Access Compliance Report

Public Rights-of-Way

(Curb Ramps)

Intersection ID: 49151	Main Street: DACAVIN_DR	Cross Street: VIDAL_LN	Location: SW
ADA ID: 3C6CE18918D8	Ramp Type: BlendTrans2	Initial Pass/Fail: Fail	Overall Compliance: No
			Severity Score: 33.75

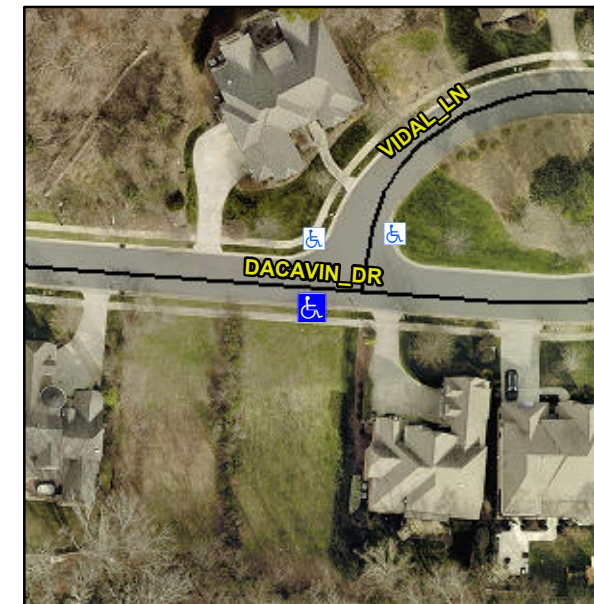
Not Found, R304.5.1, R304.5.3

Compliance	Description	Data	Compliance	Description	Data
N/A	Ramp Length (in)	93.0	Yes	BlendTrans Slope (%)	4.2
No	Ramp Width (in)	47.5	No	BlendTrans XSlope (%)	10.6
N/A	Flare Type LT	N/A	N/A	Flare Type RT	N/A
N/A	Flare Slope LT (%)	N/A	N/A	Flare Slope RT (%)	N/A
N/A	Flare Traversable LT?	N/A	N/A	Flare Traversable RT?	N/A
N/A	Landing Length (in)	N/A	N/A	DWS Provided?	N/A
N/A	Landing Width (in)	N/A	N/A	DWS Contrast?	N/A
N/A	Landing Slope (%)	N/A	N/A	DWS Length (in)	N/A
N/A	Landing X Slope (%)	N/A	N/A	DWS Full Width?	N/A
N/A	Landing Curb? (Y/N)	N/A	N/A	DWS Offset (in)	N/A
N/A	Shared Landing?	N/A			
N/A	Gutter Ponding?	N/A	N/A	Gutter Slope (%)	N/A
N/A	Gutter Lip Ht (in)	N/A	N/A	Gutter X Slope (%)	N/A
N/A	Painted X Walk1?	No	N/A	Painted X Walk2?	N/A
	X Walk 1 Direction	To N		X Walk 2 Direction	N/A
	X Walk 1 Width (in)	N/A		X Walk 2 Width (in)	N/A
	X Walk 1 Slope (%)	1.6		X Walk 2 Slope (%)	N/A
	X Walk 1 X Slope (%)	11.9		X Walk 2 X Slope (%)	N/A

N/A	Ramp inside XWalk1?	N/A	N/A	Ramp inside XWalk2?	N/A
	Road Slope (%)	11.9		Clear Space?	N/A
	Road X Slope (%)	1.6	N/A	Clear Space to XWalk (in)	N/A
N/A	Any Obstructions?	N/A	N/A	Storm Grate/Utility Hazard?	N/A
	Obstruction Type			Storm Grate/Utility Type	
		N/A			N/A
			Yes	Surface Condition? (G/P)	Good
			No	Curb Slope (%)	9.2

Remove & Replace Curb Ramp With Two New Directional Ramps or Equivalent.
